The Banks – Phase 3C
Public Infrastructure Development
Bid Package #2 – Lot 28 Park & Garage
January 13, 2022
THP #98090.40

ADDENDUM #2

DRAWING TITLE
LOWER LANDING
BLEACHER SEATING

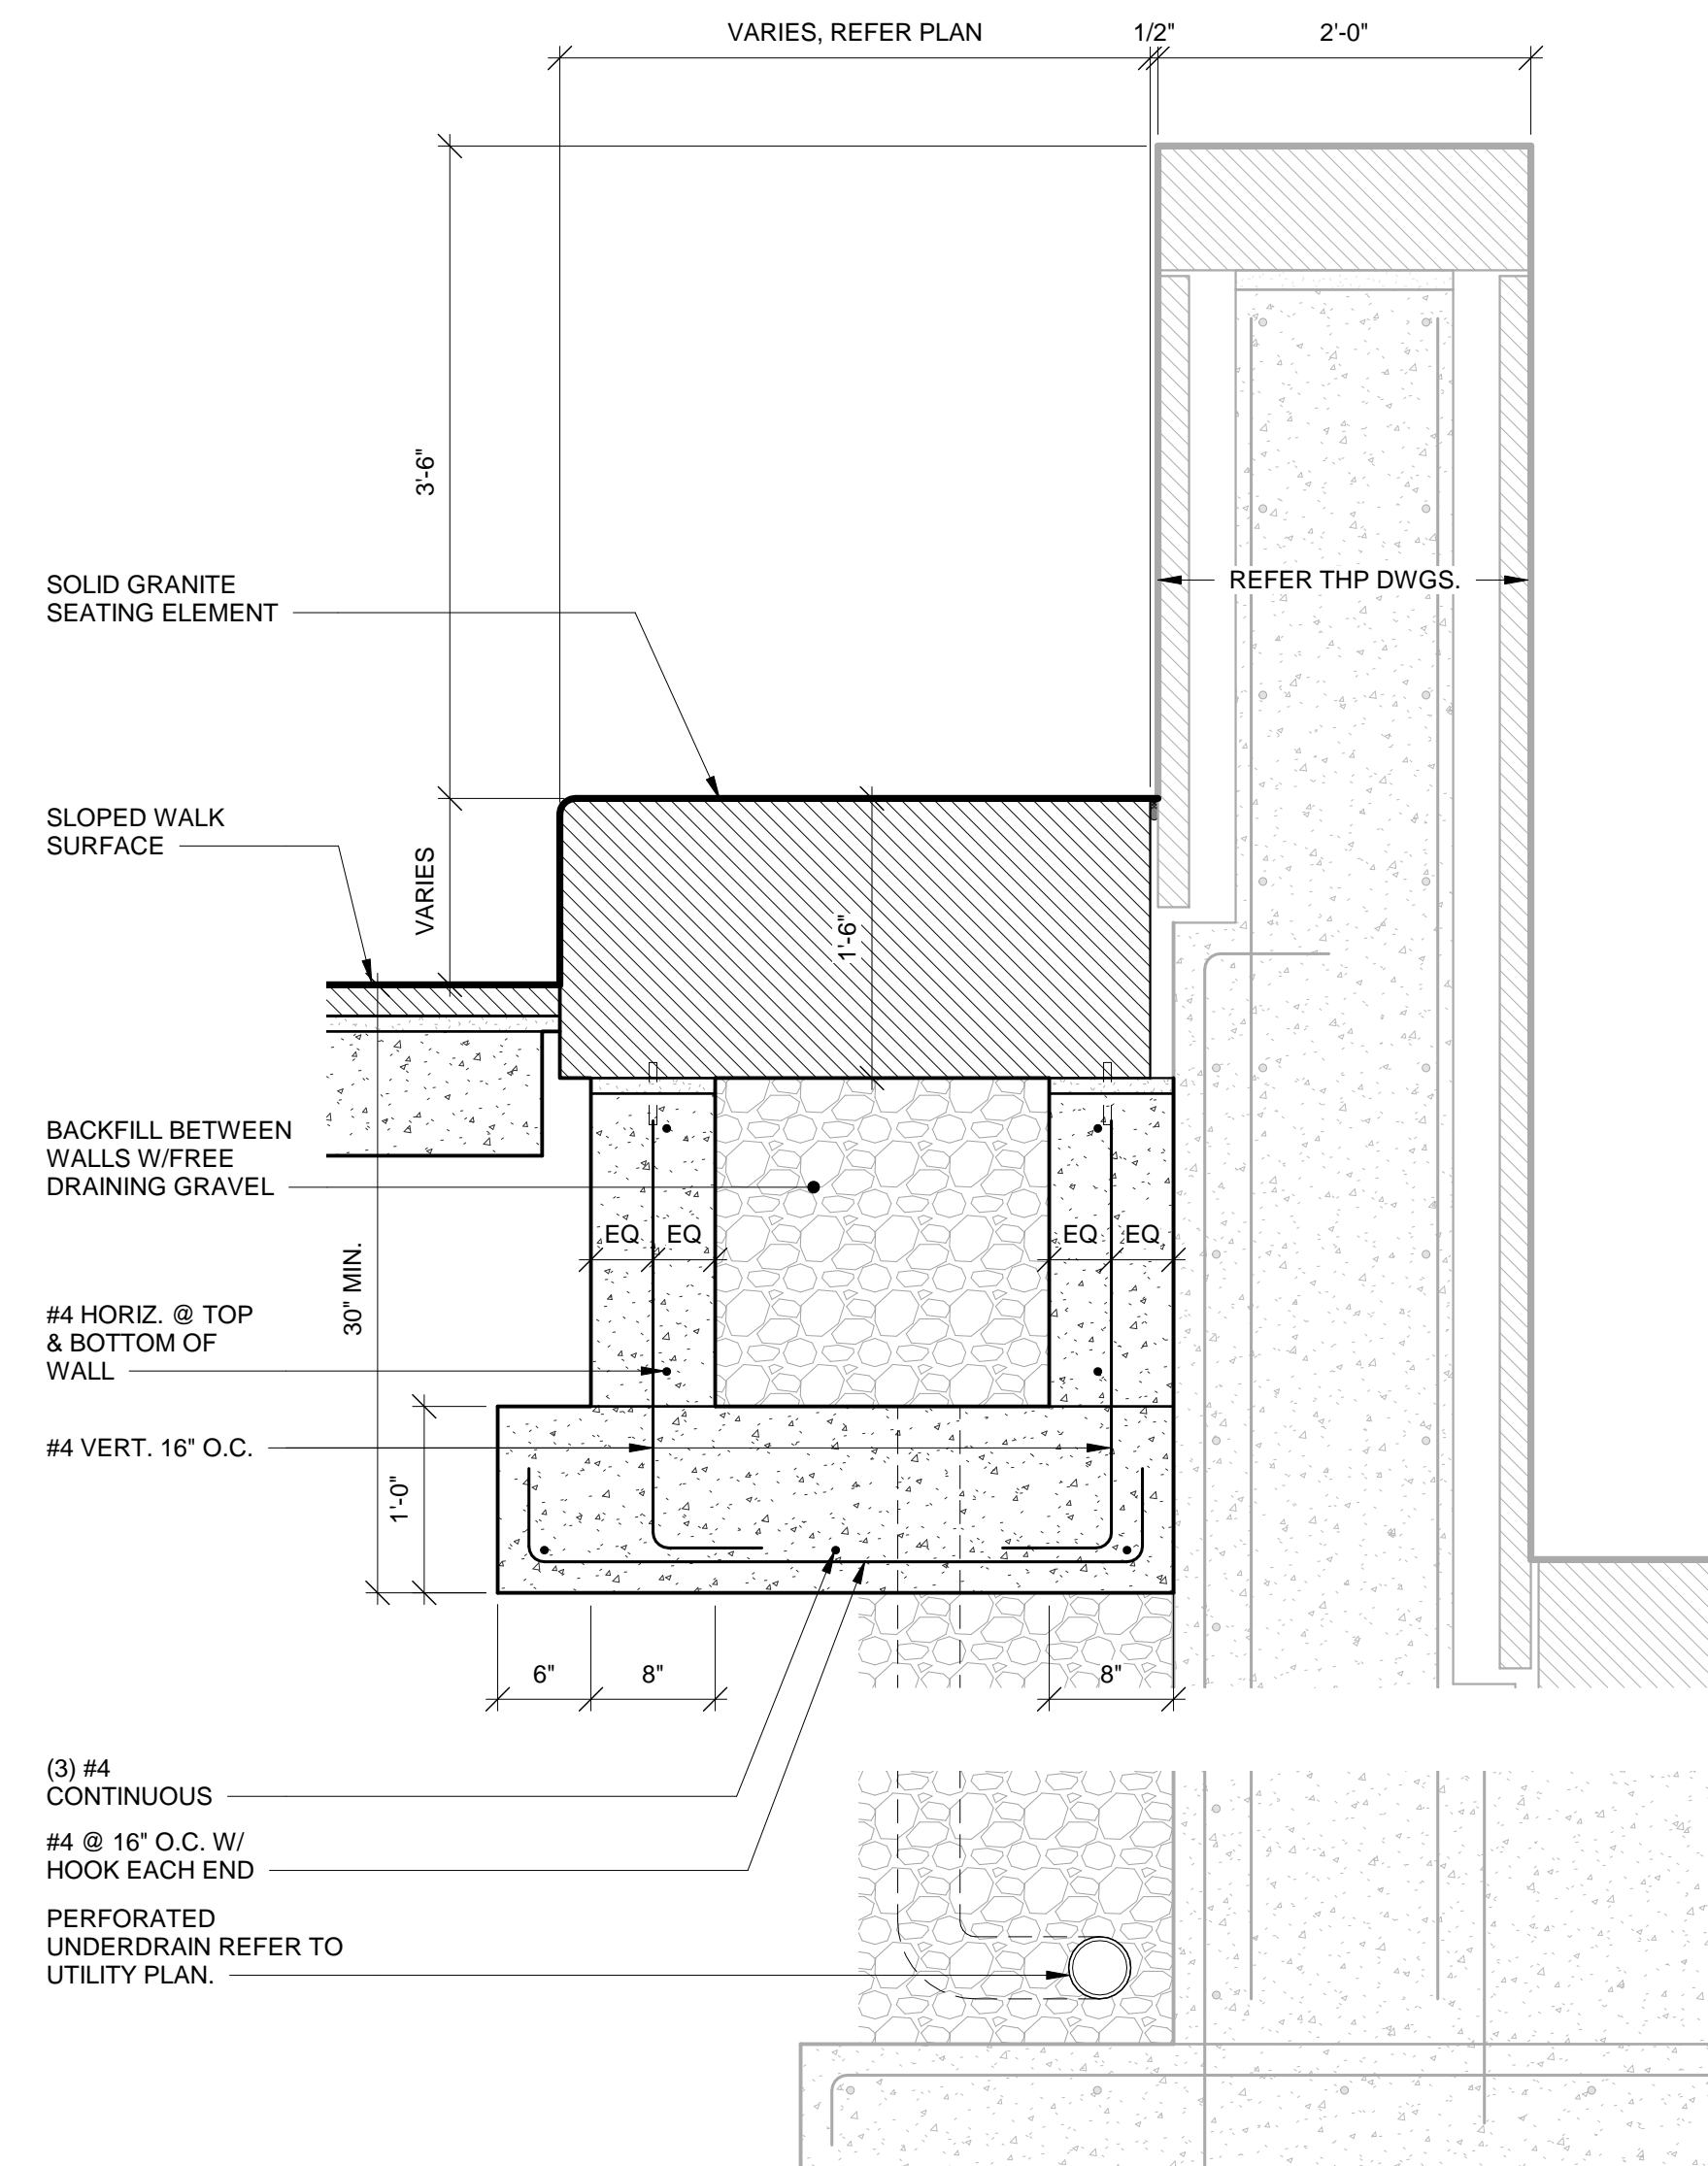
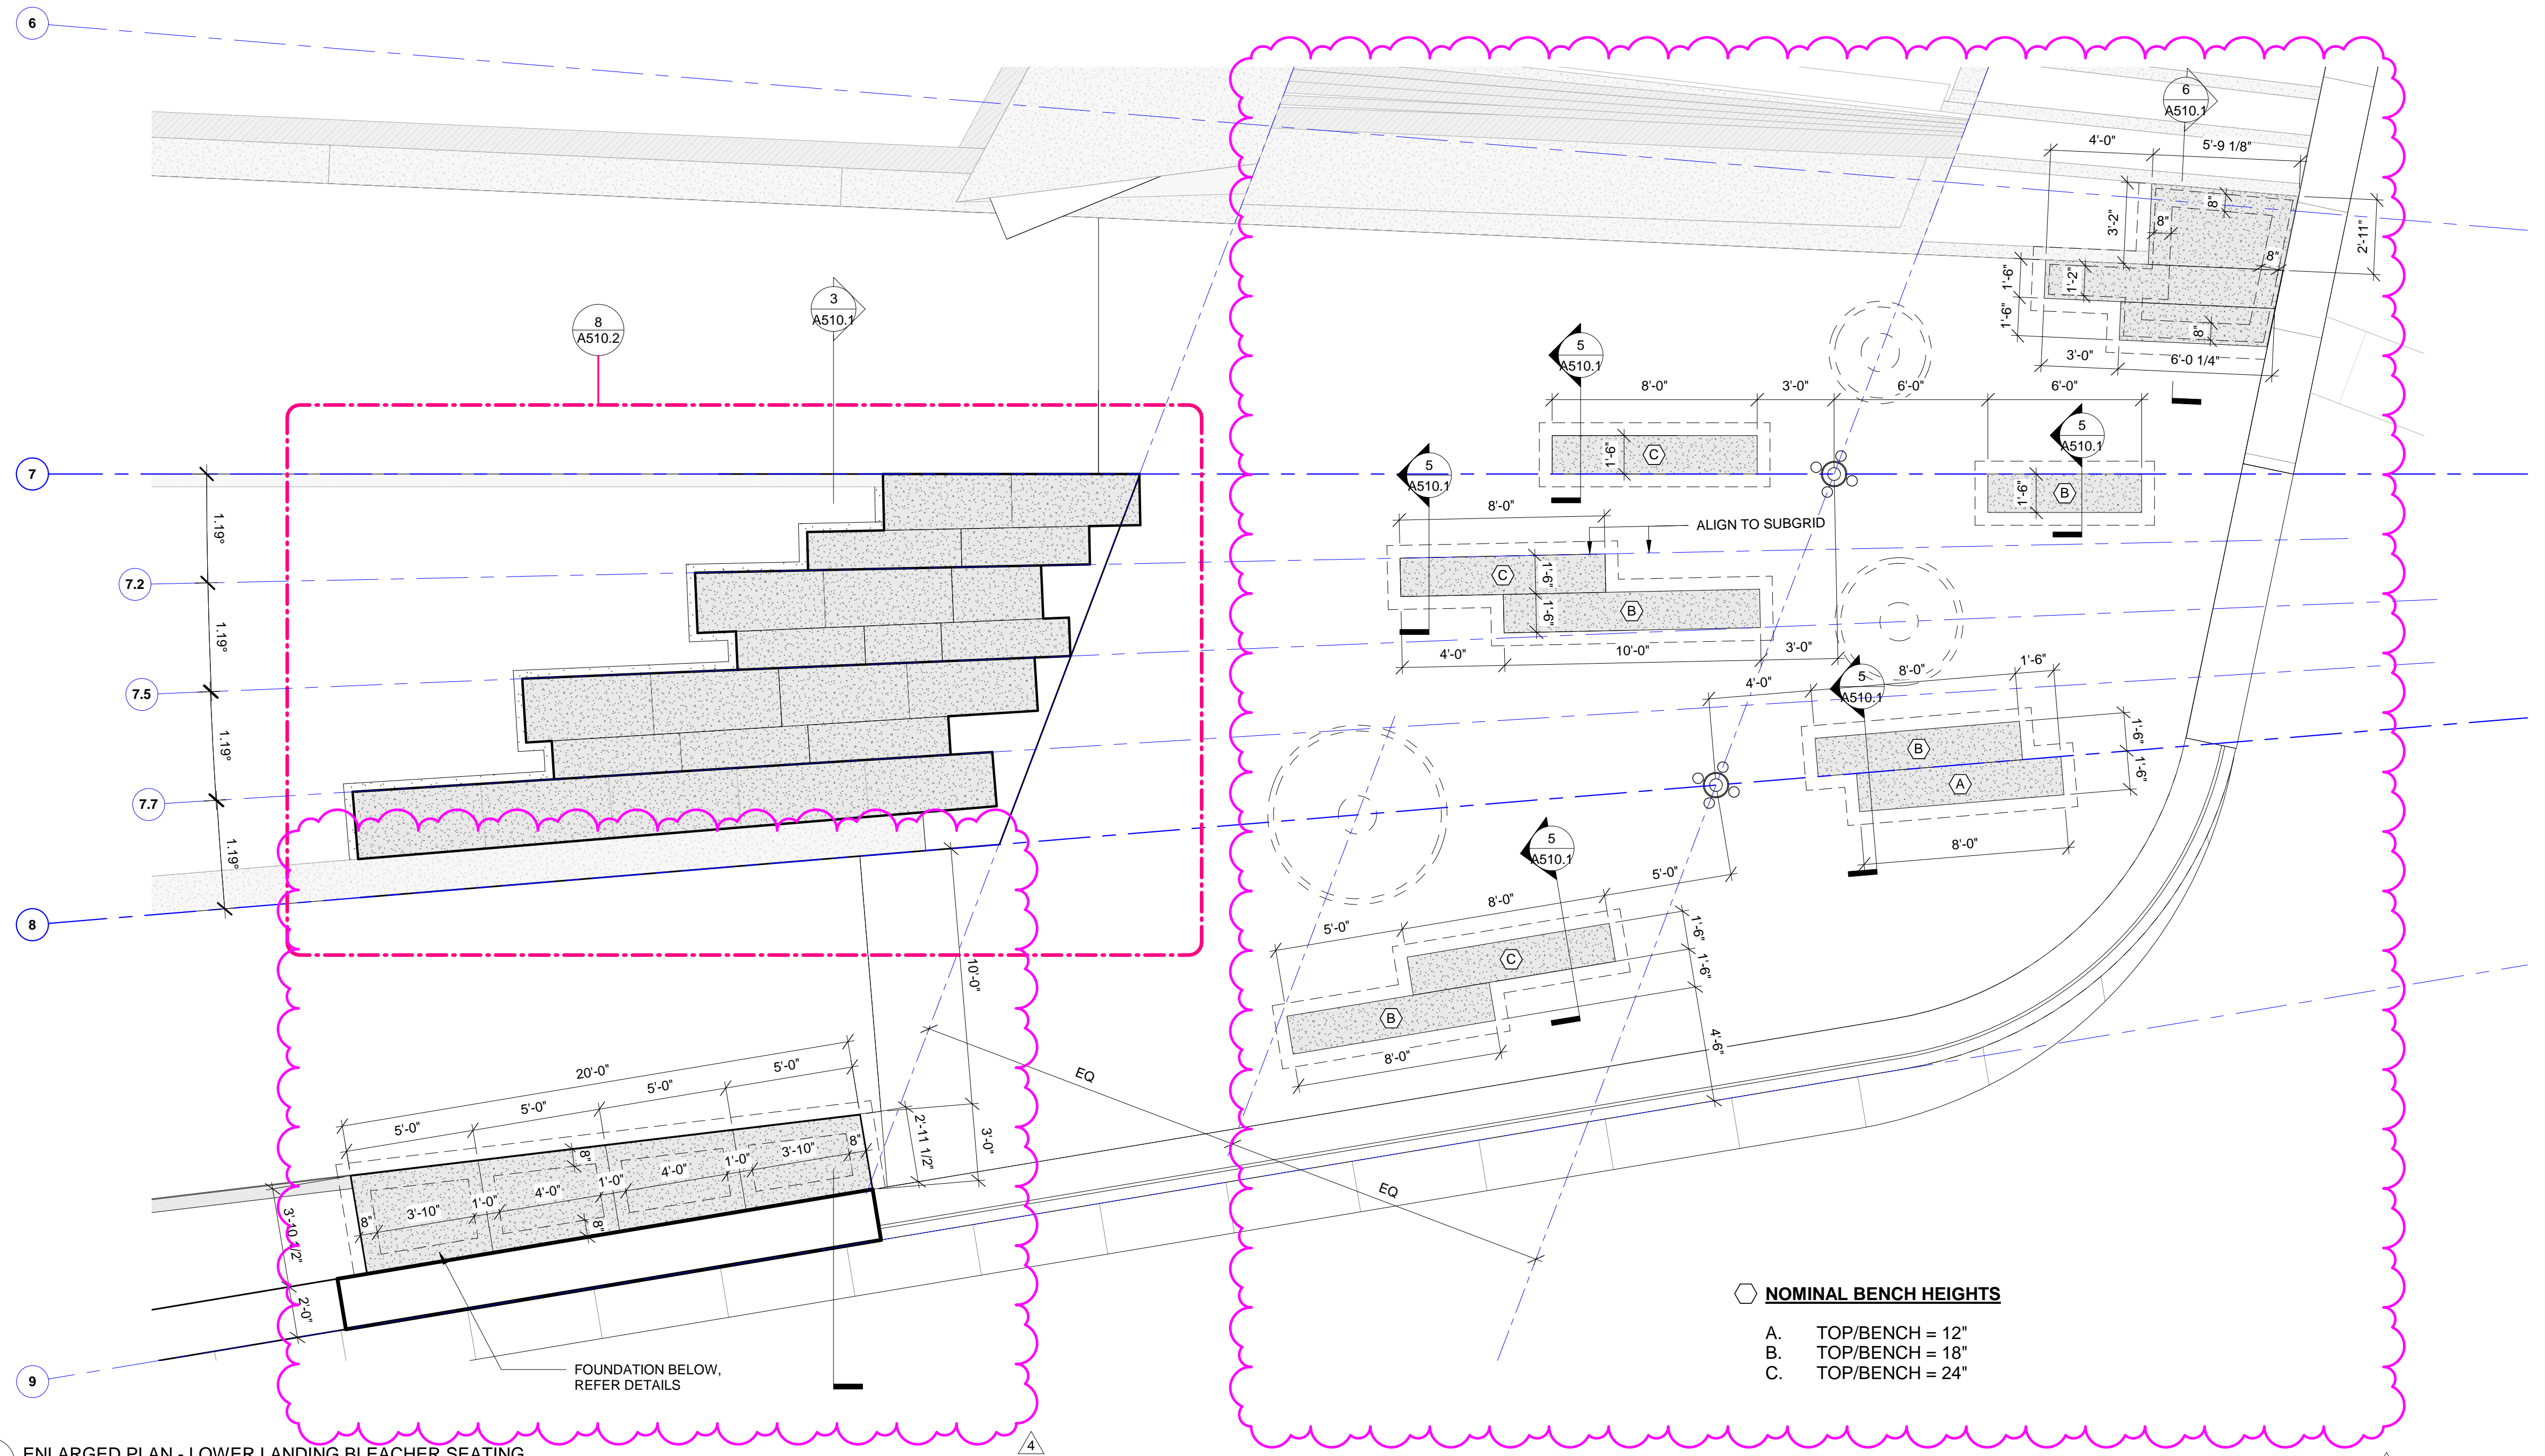
4. **A510.1** Please provide reinforcing details, elevations, and dimensions for all concrete back up foundations, for granite elements.
 - **Response to question 4:** See revised Drawing A510.1 in Addendum #2.

5. **A510.1** Detail 2/A510.1 depicts a granite structure to the east of the of the viewing screen structure. Please provide details for this area?
 - **Response to question 5:** See new Drawings A350, A351 & A352 in Addendum #2.

- Added granite bench details w/ structural notes (Baker question 4).
- Updated section w/ detail callout.
- Added new section to address east granite seat cluster (Baker question 5).
- Added notes for top of bench for scattered benches.
